Item Name: Crossstube Turning Detail

DART AEROSPACE LTD	Work Order:	94344
Description: Crosstube Assembly (205/212/412 Low Fwd)	Part Number:	D212-664-147
Inspection Dwg: D212-664-147 Rev: B		Page 1 of 2

DRAWING NO. D212-664-147	TITLE CROSSTUBE ASS'Y (205 LOW FWD)	REV. B	DART AEROSPACE LTD ENGINEERING ORDER		D.E.O. NO. D212-664-147-B-1	SHEET NO. SHEET 1 OF 1	SCALE NTS
DRAWN 92	CHECKED ASS	MFG. APPR. 183	APPROVED W.D.		DE APPR. H		
DATE 11.07.15	DATE 11.07.20	DATE 11.07.21	DATE 11/07/21		DATE 11.07.21

D212-664-147/-147B
ASSEMBLY DETAIL

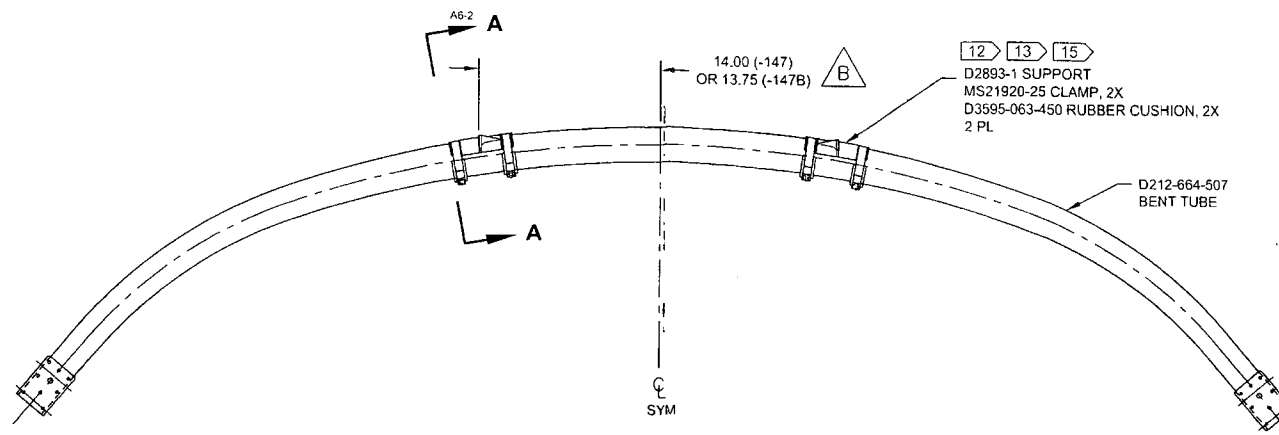
PURPOSE:

REPLACE MAGNOBOND WITH PROSEAL.

NOTE 12 & 15, SHEET 1 IS AMENDED AS FOLLOWS:

Item	Qty -147	Qty -147B	Part Number	Description
9	A/R	A/R	PROSEAL 890 B-2	SEALANT, AMS-S-8802 CLASS B-2

- 12) TO INSTALL D2893-1 SUPPORT: ABRASE MATING SURFACE OF SUPPORT AND CROSSTUBE WITH 180-GRIT SANDPAPER AND REMOVE RESIDUE WITH MEK (OR EQUIVALENT). APPLY A 0.04" TO 0.07" THICK LAYER OF PROSEAL 890 CLASS B-2 (OR AMS-S-8802 CLASS B-2) SEALANT TO MATING SURFACE OF SUPPORT.
- 15) TORQUE CLAMPS 80 TO 100 IN-LB. ENSURE AT LEAST 1.5 THREADS SHOWING IN SAFETY AND THAT NUT HAS NOT BOTTOMED-OUT AFTER TORQUING. **PRIOR TO PACKAGING, RE-CHECK TORQUE ON CLAMPS AFTER PROSEAL 890 SEALANT HAS CURED FOR 72 HOURS.**
